Service Bulletin

No. : OST-C1528

Model: POA-A1HDCI

Subject: Change the voltage of power supply for OP amplifier.
Countermeasure is applicable only upon claim from the customer.

1) 1U-3798-1 AMP UNIT:

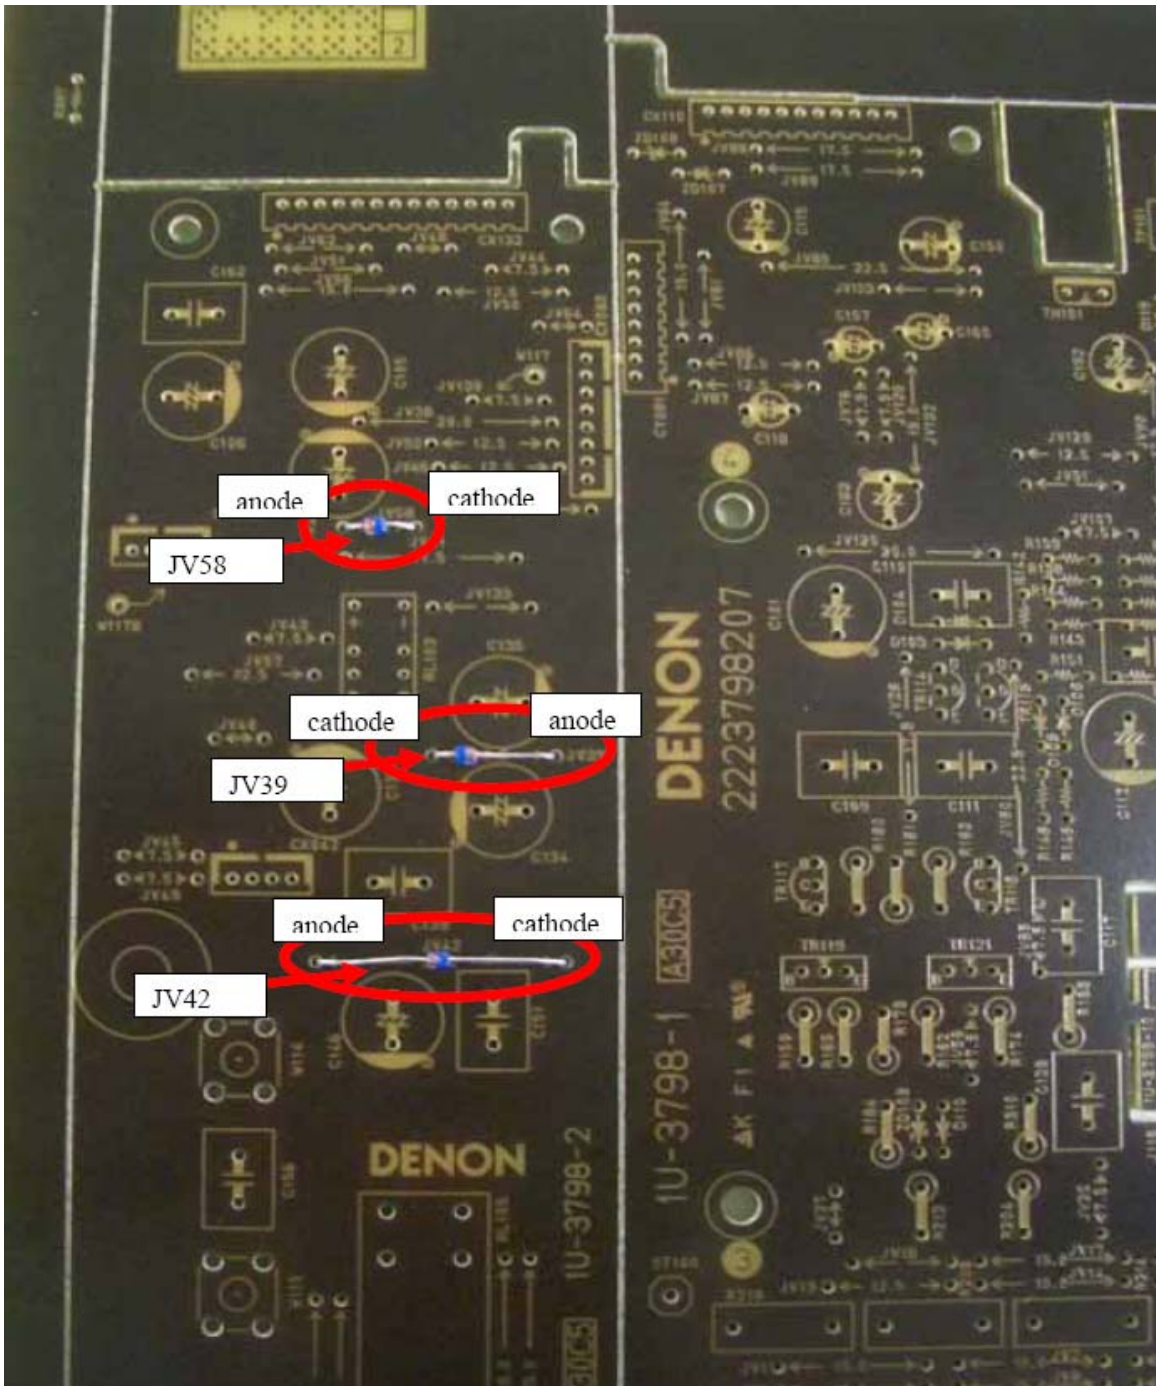
COUNTERMEASURE: We pulled down the voltage of the power supply from "+18/-18 volts" to "+15/-15 volts".

a) IC102, IC103: SA5532ADR (00D2623555901)→NJM5532M-D (TE-1)(00D2630898907)

b) ZD101, ZD102: HZS22-1 (00D2760480900)→HZS20-1TD (00D2760479908)

2) 1U-3798-2 INPUT UNIT: a) JV39, JV42, JV58: Jumper Wire→HZS3B-2TD (00D2760453911)

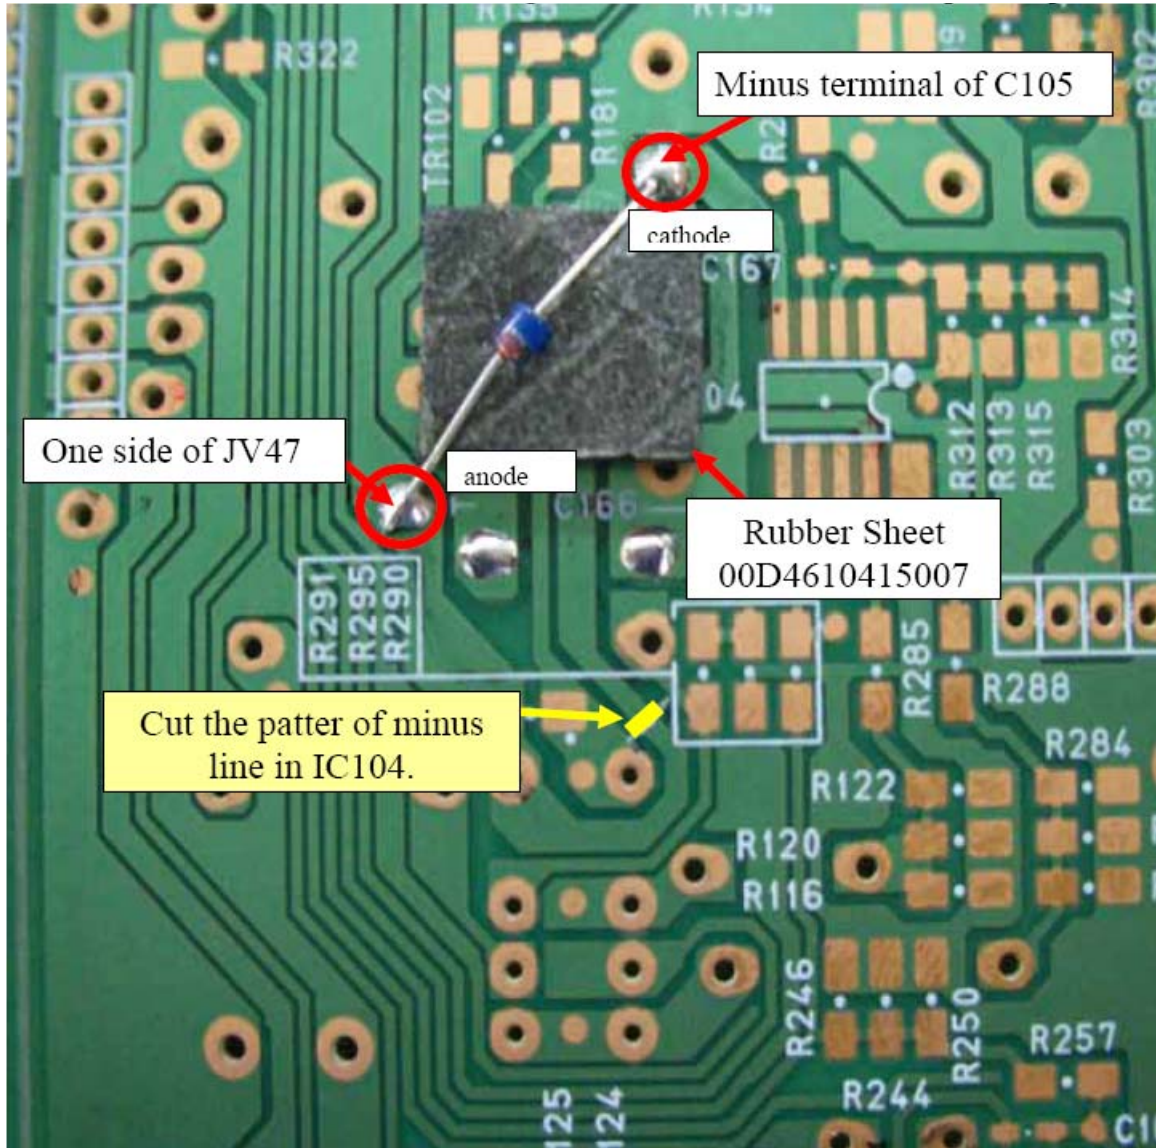
- b) Cut the pattern of minus line in IC104.
c) Solder the diode HZS3B-2 to the PCB with a RUBBER SHEET under the component (on PC board).

d) IC101, IC104: SA5532ADR (00D2623555901)→SE5532AD8R2G (232810020503S)

3) 1U-3797-3/4/5/6/7 CONNECT UNIT:

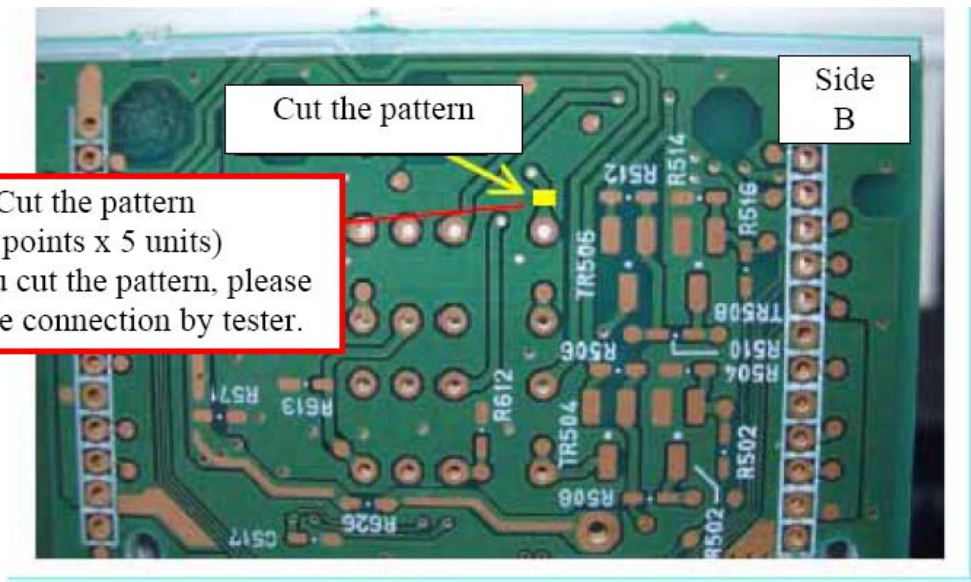
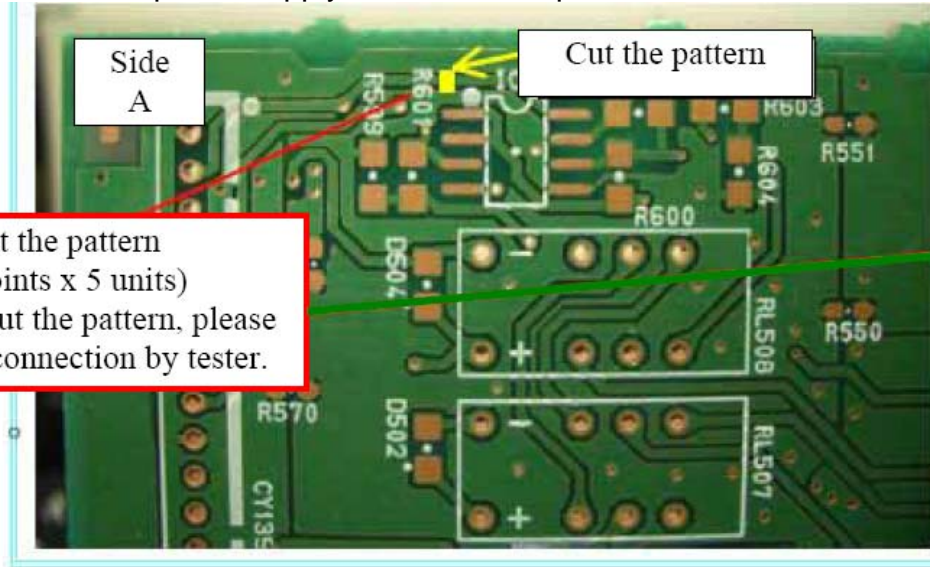
a) IC511, IC512, IC513, IC514, IC515: SA5532ADR (00D2623555901)→SE5532AD8R2G (232810020503S)

b) Cut the pattern of the power supply line for OP amplifier.

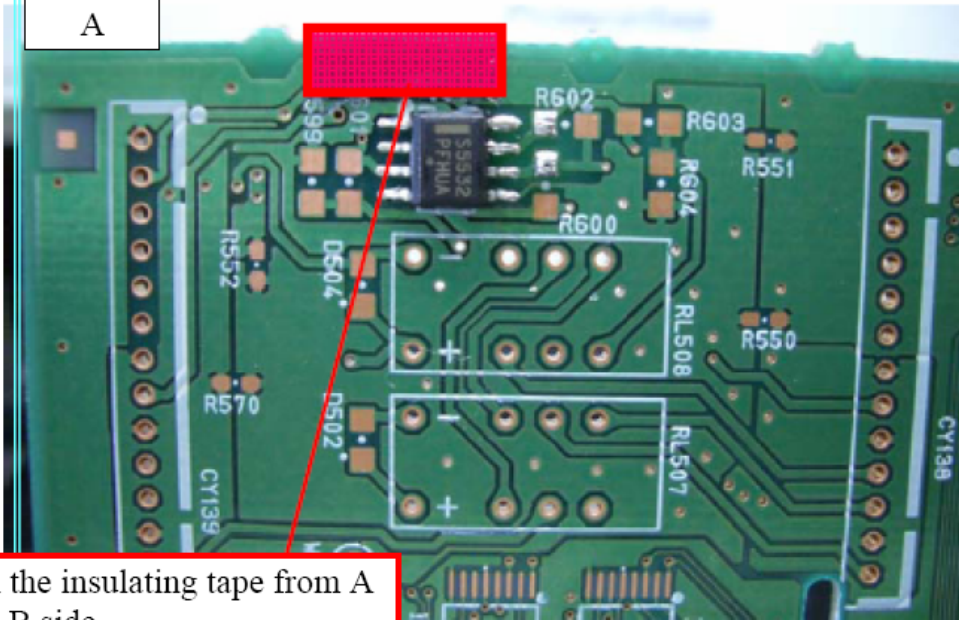
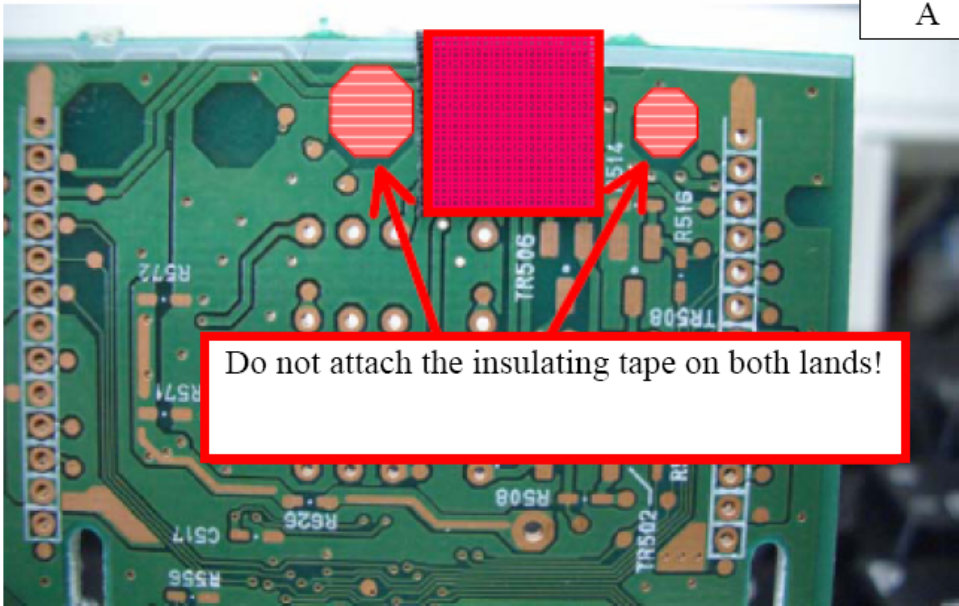
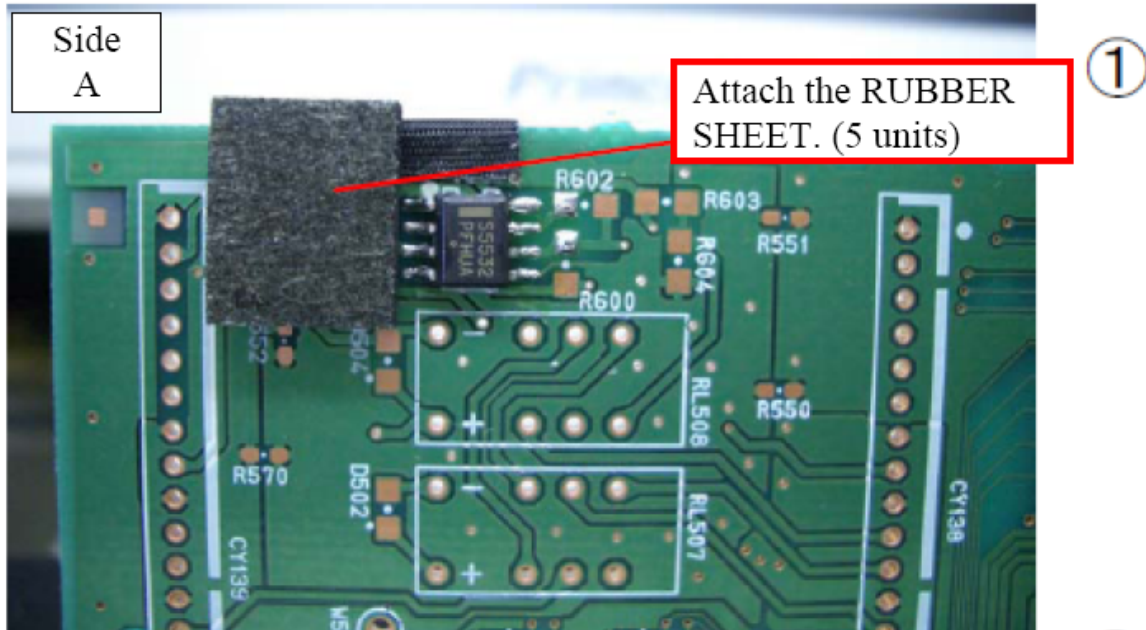
Attach the insulating tape from A side to B side.
(W=10mm x L=15mm)

Do not attach the insulating tape on both lands!

Attach the insulating tape
from A side to B side.

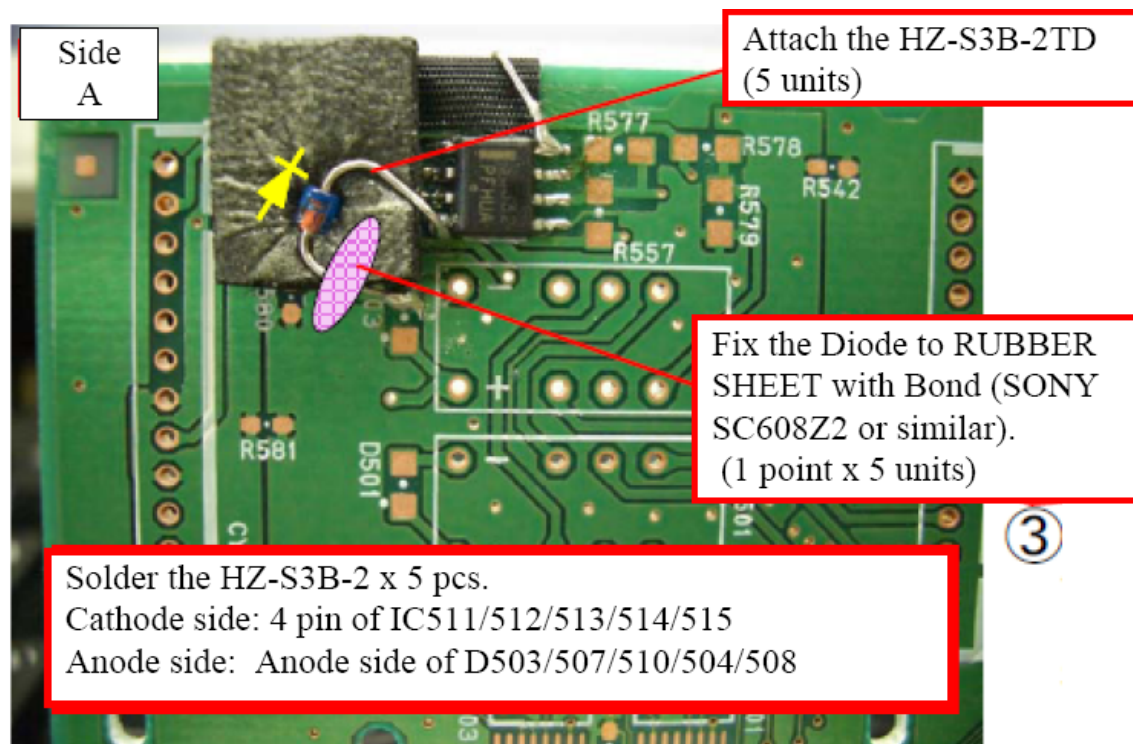
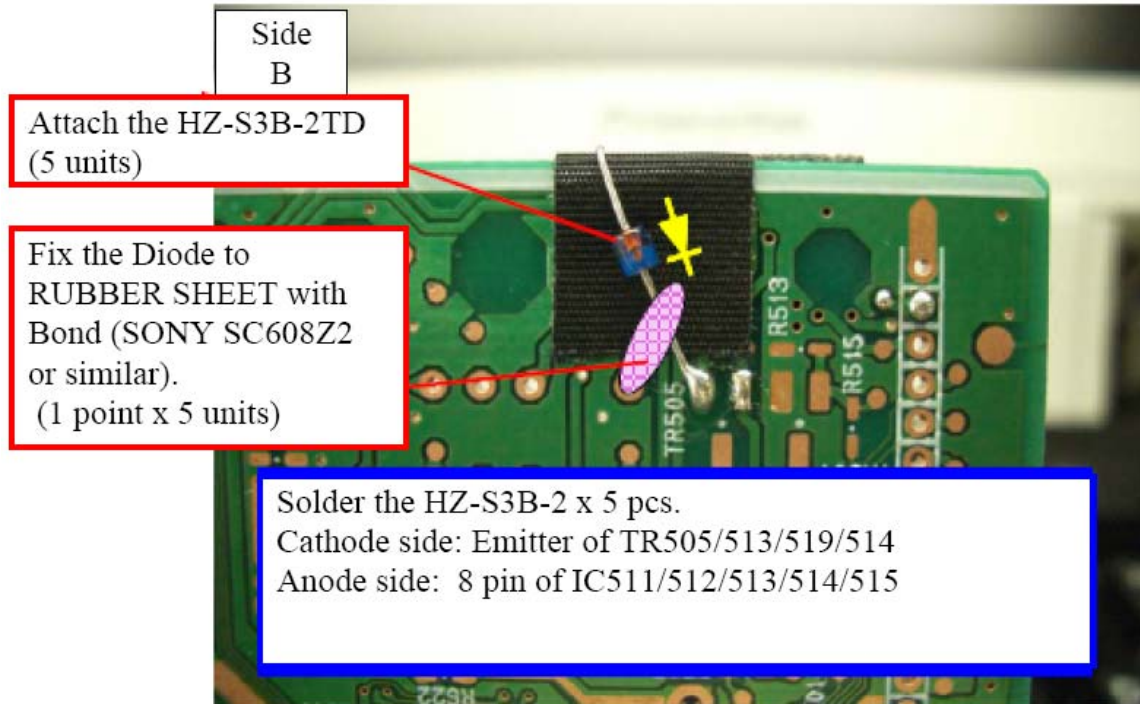
c) Attach the RUBBER SHEET and cloth tape on the printing board.

d) Attach the HZS3B-2 (00D2760453911) on the A side of printing board.
